Proposed Nature and Extent of Deviation: The deviation is a request for the following local roadway intersections closer than 200 feet from a Non-Residential Collector:

Review and Recommendation:
APPROVED by the ECM Administrator

Deviation Requests

Springs at Waterview East (LSC #184360)

Figure 4

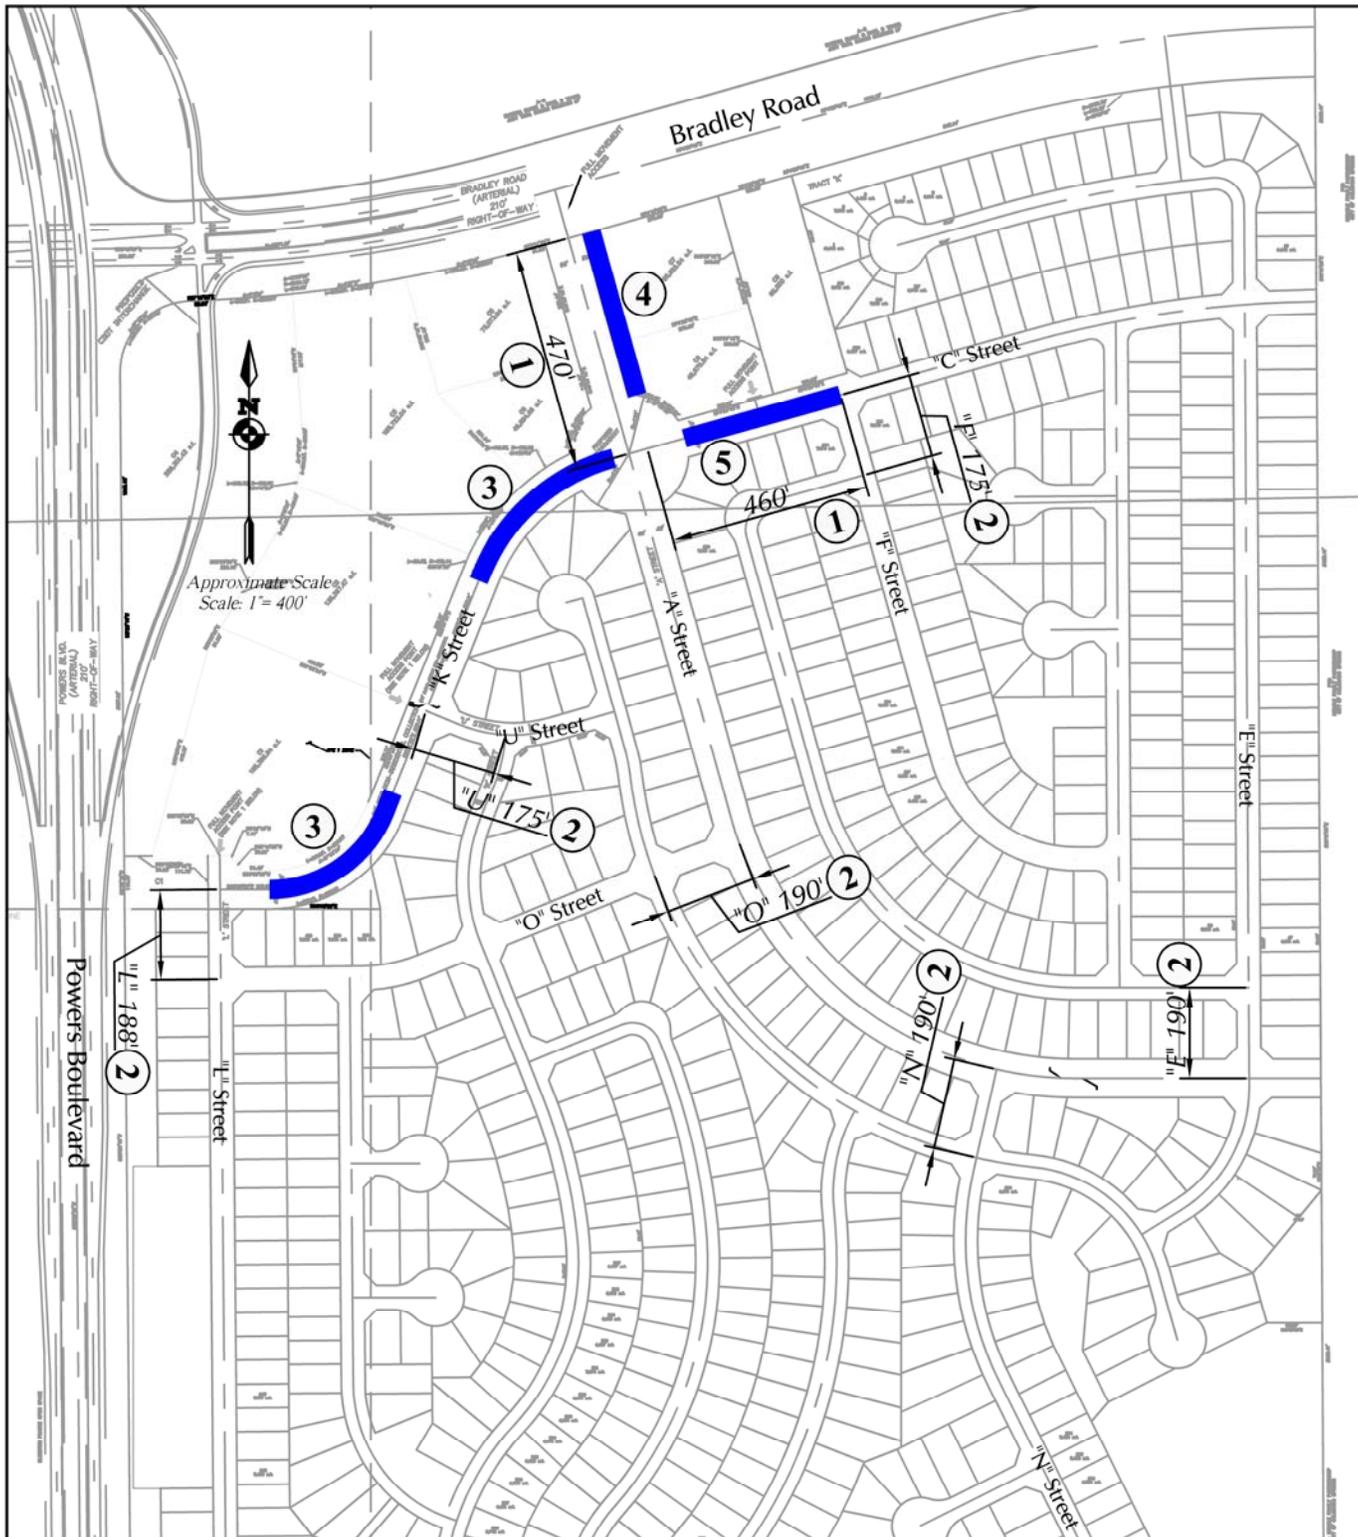
- "E" Street 190 feet north of "A" street
- "F" Street 175 feet south of "C" street
- "N" Street 190 feet south of "A" street
- "O" Street 190 feet west of "A" street
- "O" Street 188 feet south of "K" street
- "U" Street 175 feet south of "K" street.

Reason for the Requested Deviation: Given a combination of factors -- the Powers Boulevard access restriction, the requirement to reserve future ROW for a Bradley/Powers grade-separated interchange, limited access to Bradley Road, limited connections to the City property to the east and no current available streets to the south, and the need to achieve the planned lot sizes -- the resulting street layout resulted in several of the segments of proposed Urban Local street to be shown slightly below the 200-foot spacing criteria.

- "E" Street 190 feet north of "A" street - 10 feet short of the 200' criteria.
- "F" Street 175 feet south of "C" street - 25 feet short of the 200' criteria.
- "N" Street 190 feet south of "A" street - 10 feet short of the 200' criteria.
- "O" Street 190 feet west of "A" street - 10 feet short of the 200' criteria.
- "O" Street 188 feet south of "K" street - 12 feet short of the 200' criteria.
- "U" Street 175 feet south of "K" street - 25 feet short of the 200' criteria.

Except the 175-foot spacing to the first intersection back from a Collector for U and F Streets, the other streets listed would be within 12 feet of the 200-foot standard. The segments along U and F street for which a deviation is requested would not have back-to-back left turning movements along these segments as the first intersection back from the collector would be a T intersection with only through and right turning movements approaching the first Local street intersection when traveling outbound from the Collector/Local intersection (except, perhaps, for the individual lots adjacent to the intersection).

The segments along U and F street for which a 25-foot spacing deviation is requested would not have back-to-back left turning movements along these segments as the first intersection back from the collector would be a T intersection. The other street segments listed in the deviation would be either 10 feet or 12 feet short of the 200-foot standard. These minor differences would have little impact on traffic operations.

This request has been determined to have met the criteria for approval. A deviation from Section 2.2.5E of ECM is hereby granted based on the justification provided. Comments: Approval of this deviation is limited to the layout as shown in this preliminary plan. Any changes to this layout or zoning shall void this approval.
